PCN#20170613005B
Qualification of Hefei Tongfu Microelectronic Co. Ltd (HFTF) as additional Assembly and Test Site for Select Devices
Change Notification / Sample Request

PCN Number:	20170613005B	PCN Date:	Oct 24, 2017
Title:	Qualification of Hefei Tongfu Microelectronic Co. Ltd (HFTF) as additional Assembly and Test Site for Select Devices		
Customer Contact:	PCN Manager	Dept:	Quality Services

Sample product shipping label (not actual product label)

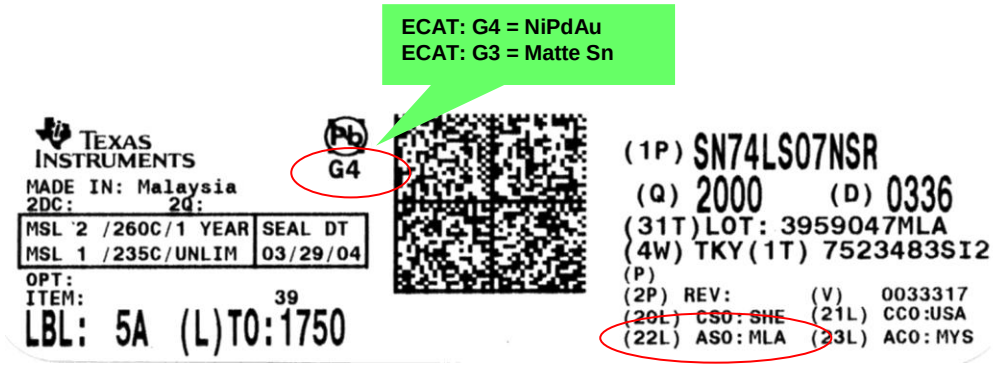
Group 2 Device:

Assembly Site			
NFME	Assembly Site Origin (22L)	ASO: NFM	ECAT: G4
HFTF	Assembly Site Origin (22L)	ASO: HFT	ECAT: G3

ASSEMBLY SITE CODES: NFME = E, HFTF = J
